Application for a Certificate of Appropriateness Date: February 13, 2019 PID# 11909401

LOCAL HISTORIC DISTRICT: Wilmore

PROPERTY ADDRESS:	1768 Merriman Avenue
SUMMARY OF REQUEST:	Addition + Accessory Building
APPLICANT/OWNER:	Jim Wood

HDC-2019-00004 PID: 11909401 LOCAL HISTORIC DISTRICT: WILMORE PROPOSED PROJECT: ADDITION

Site Plan

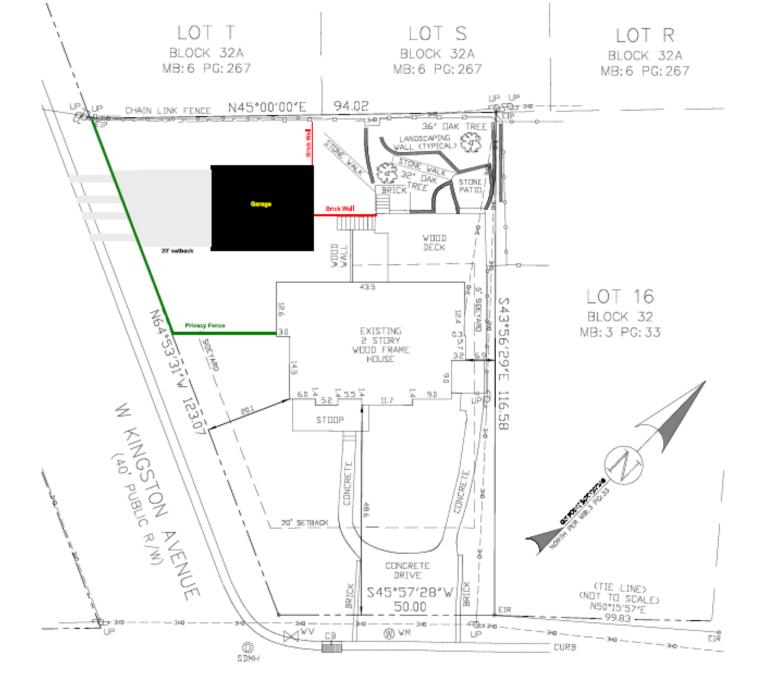
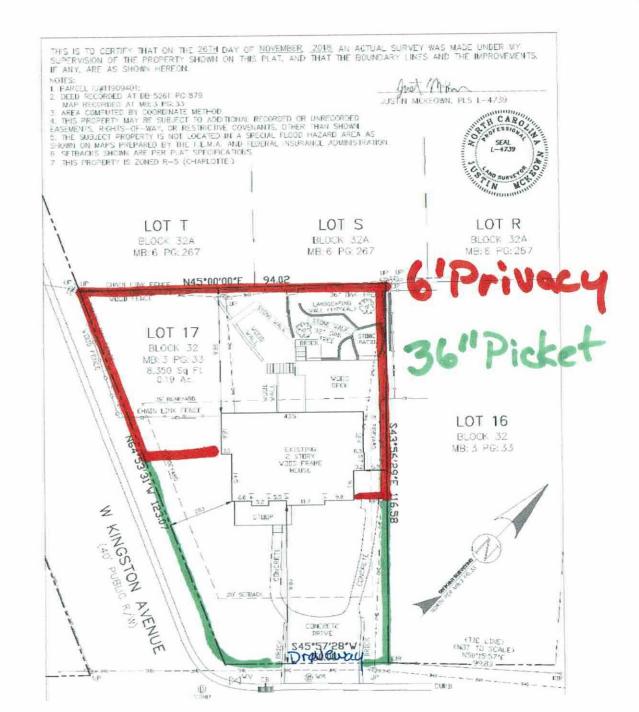
- 1. Accurate site plan with siting of the garage, siting of the fence, gate, and landscaping.
- 2. Showing precedent for privacy fence in side yard.

- 1. Updated site plan with siting of garage, fence, gate and landscaping.
- 2. Provided examples throughout Wilmore of garages + fences on corner lots.
